DEIR Public Comment to the Proposed Accretive Lilac Hills Ranch General Plan Amendment and Specific Plan PDS2012-3800-12-001 (GPA), PDS2012-3810-12-001 (SP)

Valley Center Community Planning Group Comments:

Chapter 4: Draft Environmental Impact Report (DEIR) Project Alternatives

FIGURE 4-3
Reduced Footprint Alternative

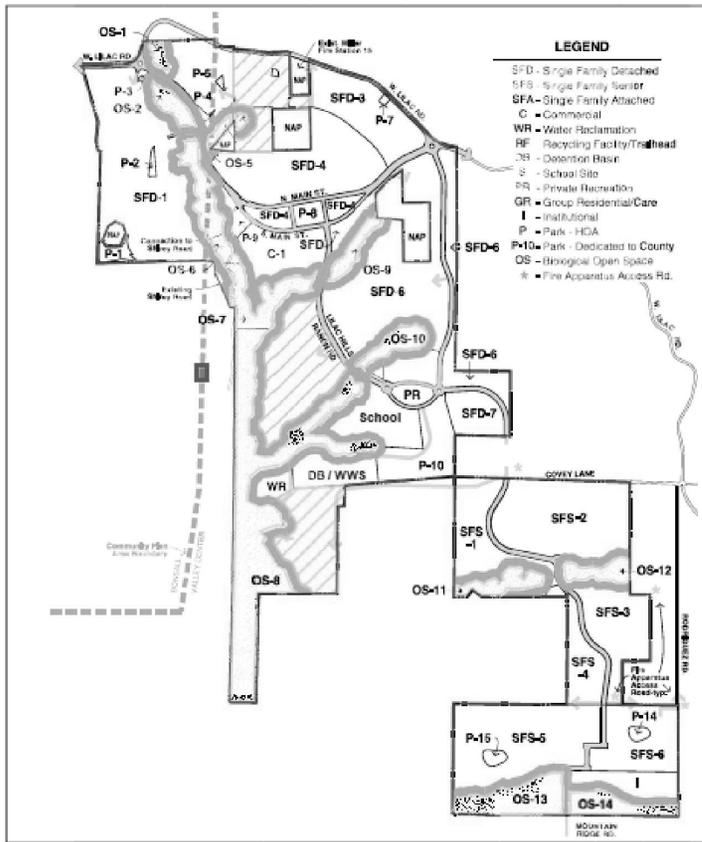
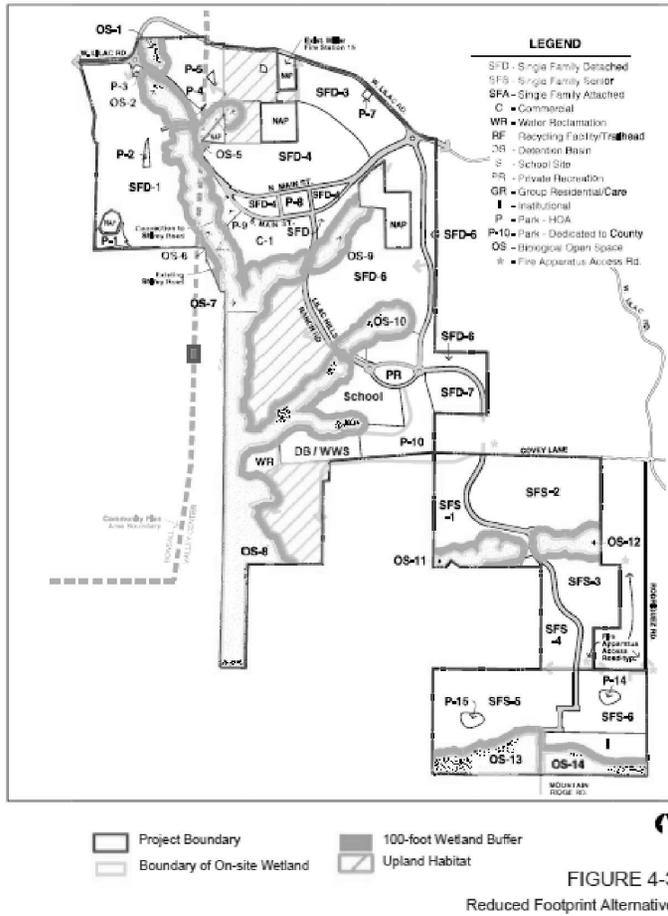
These Alternatives are described inadequately. The Applicant's information has multiple math errors (refer to Attachment B – Table 4-1 from DEIR Chapter 4 Project Alternatives). The only other information provided is a one page Map that in two Alternatives did not even perform lot allocation (Attachment C- Reduced Footprint Map

This is a deficient level of detail to assess Environmental Impact. There is no definition of Commercial uses and zoning. Despite the naïve arm waving in DEIR Chapter 4, traffic impacts are not linear mathematical relationships. And the list of similar issues to Traffic is very long.

C1f-29 Table 1 presented in this comment, is reflective of Table 4-1 that was circulated in the June 2013 EIR. This table was revised in 2014 when the Draft Revised EIR was sent out for public review. As now shown in Table 4-1 in the FEIR, all columns add to a total of 608 acres. Table 4-1 in the FEIR provides a matrix of the proposed land uses for each of the Alternatives. This table is accurate and does not require revision. These alternatives are valid alternatives and are adequately described in the FEIR. The information and analysis in Chapter 4.0 provides sufficient detail to complete an adequate analysis of impacts associated with each alternative.
